Notice of Decision

1490 Dike Access Road Site Plan Review

Land Use Application Nos.:	SPR 21-013 (Site Plan Review) SEP 20-002 (SEPA)
Applicant:	Collins Architectural Group 950 12 th Ave Ste 200 Longview, WA 98632
Property Owner:	Singh Ravi/Mand Satveer Etal 4601 NE 126 th Circle Vancouver, WA 98665
Site Location:	1490 Dike Access Rd Woodland, Wa 98647
Parcel No. & Size:	507870116 0.22 Acres
Zoning Designation:	Highway Commercial (C-1)
Date Application Received:	December 29, 2021
Notice of Complete Application Issued:	January 3, 2022
Notice of Application & Likely DNS issued:	January 4, 2022
Comment Period & SEPA Appeal Period Ended:	N/A
Notice of Decision Issued:	January 13, 2022
DRC Decision	Approve with Conditions

A. Site Plan

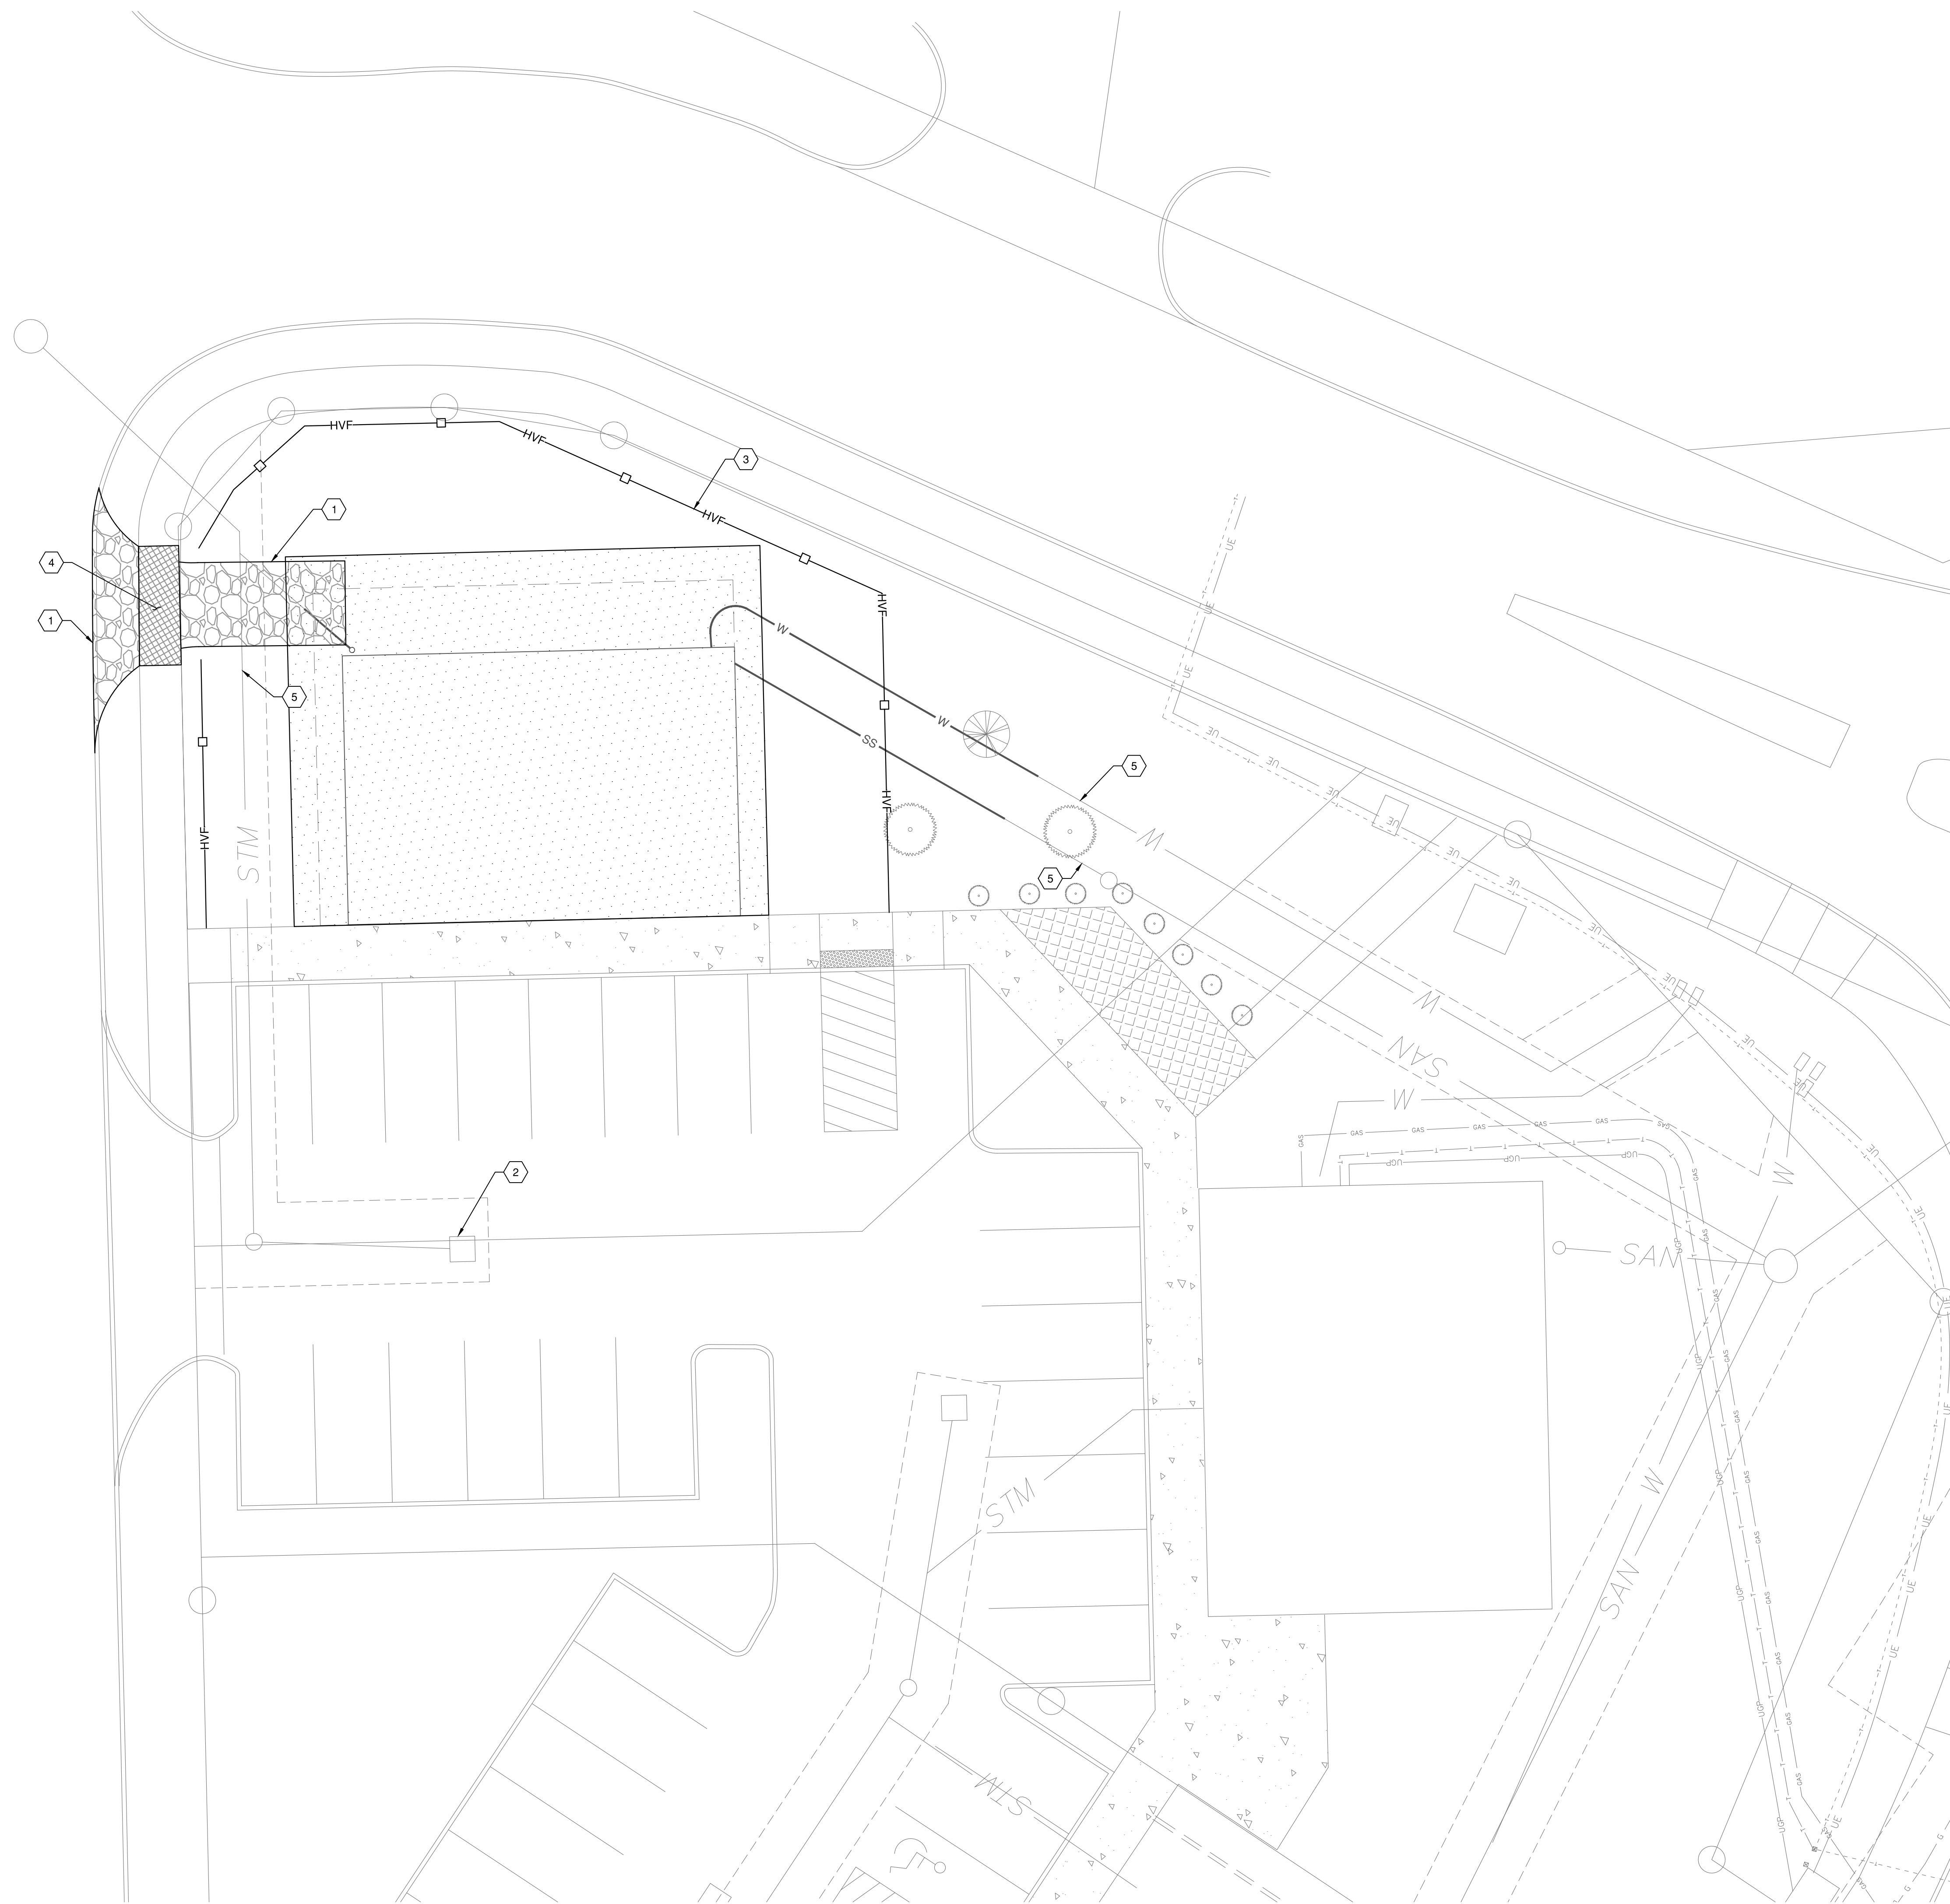
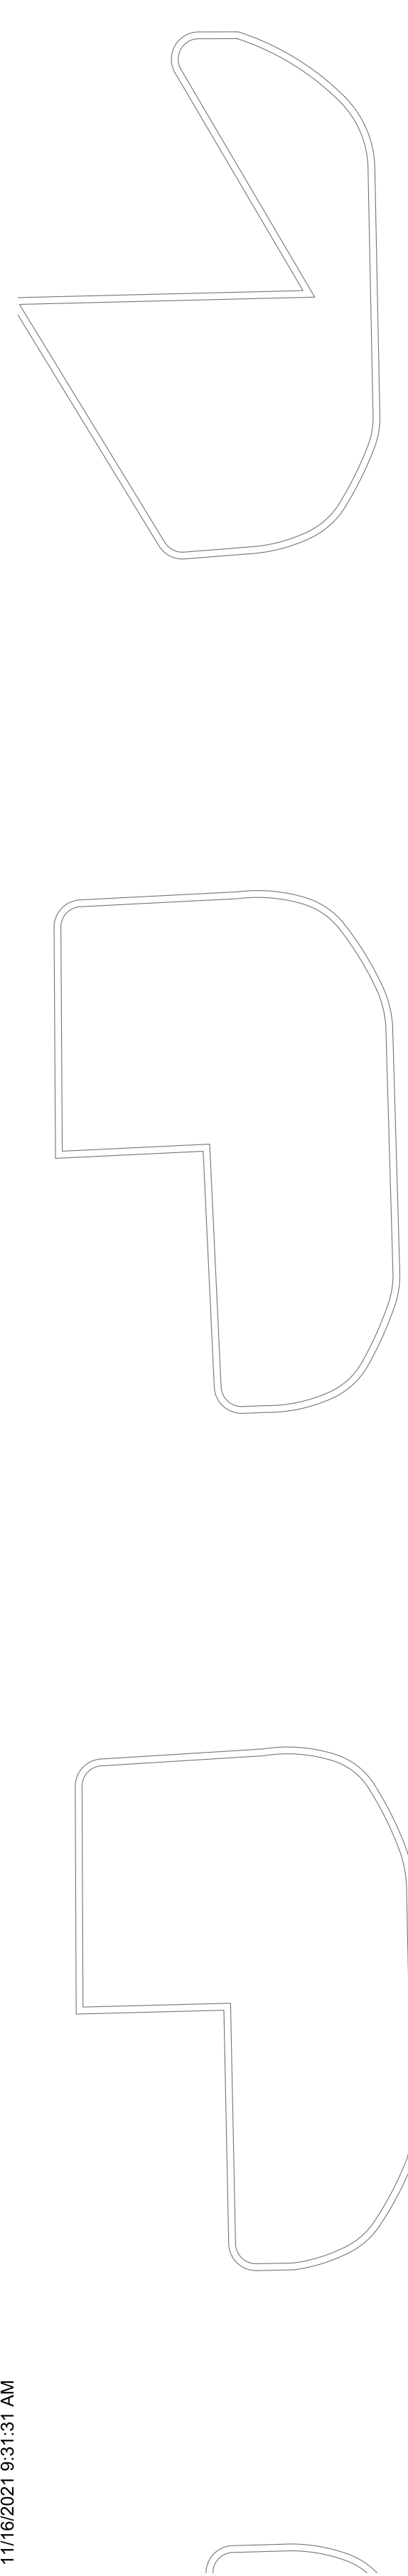
Finding 7: Plans submitted for review show an entrance facing away from the street with limited windows facing East towards Dike Access Road frontage. This configuration does not meet the standards established but would be viewed as compatible with WMC 17.36.130 (E) and WMC 17.36.130 (H)(4) with the addition of windows facing East (See condition #1).

Finding 14: WMC 17.36.130 (M) requires clearly defined pedestrian connection between abutting public street(s) and building entrances. Submitted plans do not show a proposed pedestrian connection to Schurman way for the proposed development. A condition has been added which requires a pedestrian connection be added. (See conditions # 2 and # 3)

Finding 16: The applicant has provided plans showing that existing landscaping will be removed/disturbed but has not provided a detailed landscaping plan that meets WMC 17.36.130 (N). (See condition # 4 and # 5)

1. The building design shall be revised to ensure that the east face meets the architectural standards for transparency of glass of WMC 17.36.130(H)(4)(a) which requires a minimum of 30% of the street facing façade to be comprised of windows with clear vision glass. The review of this design may be completed as part of the building permit application review, or the design can be reviewed and approved by the planner prior to building permit submittal.

2. A revised final plan, that includes a pedestrian connection Schurman Way and the building shall be added to make it compliant with WMC 17.36.130 (M).

5. Any existing shrubs or trees removed from the site as a result of this project, shall be replaced as part of the landscaping plan for this development. Removed and replaced plants must be identified in the approved landscaping plan. Landscaping must be approved prior to installation and installed prior to final occupancy of the building.
